**PLANNED UNIT DEVELOPMENT
& SUBDIVISION STAFF REPORT****Date: November 5, 2015****DEVELOPMENT NAME**

Smith Memorial A.M.E. Church Subdivision

LOCATION6501 Felhorn Road North
(Southwest corner of Felhorn Road North and Roslyn Drive West).**CITY COUNCIL
DISTRICT**

**REVISED ENGINEERING
COMMENTS**

PROPOSED SITE PLAN

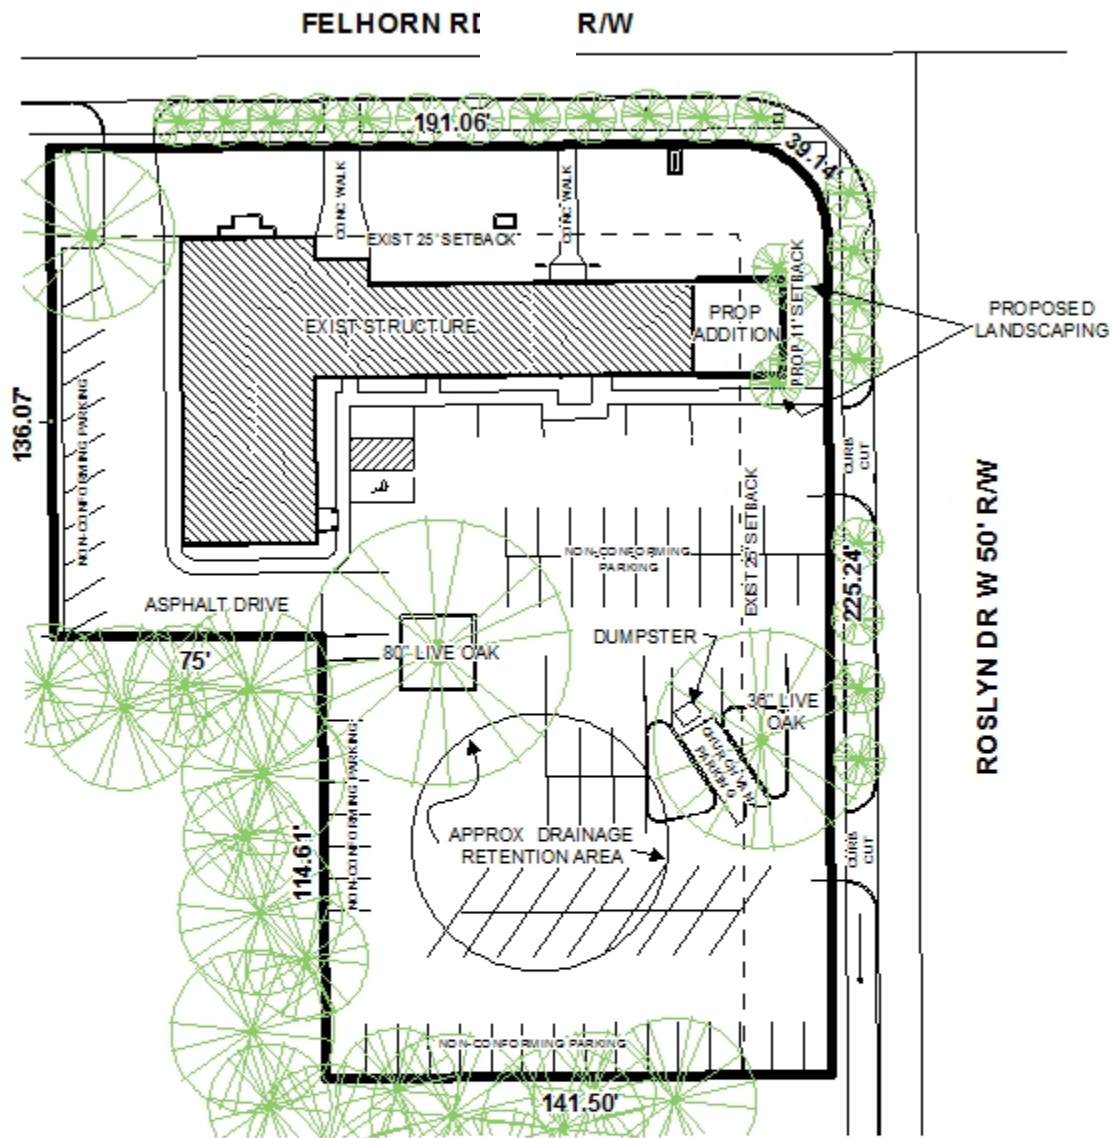
ADD THE FOLLOWING NOTES TO THE PUD SITE PLAN:

- 1. Any work performed in the existing ROW (right-of-way) such as driveways, sidewalks, utility connections, grading, drainage, irrigation, or landscaping will require a ROW permit from the City of Mobile Engineering Department (208-6070) and must comply with the City of Mobile Right-of-Way Construction and Administration Ordinance (Mobile City Code, Chapter 57, Article VIII).

- 2. A Land Disturbance Permit application shall be submitted for any proposed land disturbing activity with the property. A complete set of construction plans including, but not limited to, drainage, utilities, grading, storm water detention systems, paving, and all above ground structures, will need to be included with the Land Disturbance permit. This Permit must be submitted, approved, and issued prior to beginning any of the construction work.

- 3. Any and all proposed land disturbing activity within the property will need to be submitted for review and be in conformance with Mobile City Code, Chapter 17, Storm Water Management and Flood Control; the City of Mobile, Alabama Flood Plain Management Plan (1984); and, the Rules For Erosion and Sedimentation Control and Storm Water Runoff Control.

- 4. The detention facility shall be maintained as it was constructed and approved. The Land Disturbance Permit application for the construction shall include a Maintenance and Inspection Plan signed and notarized by the Owner(s). This Plan shall run with the land and be recorded in the County Probate Office prior to the Engineering Department issuing their approval for a Final Certificate of Occupancy.

- 5. The approval of all applicable federal, state, and local agencies (including all storm water runoff, wetland and floodplain requirements) will be required prior to the issuance of a
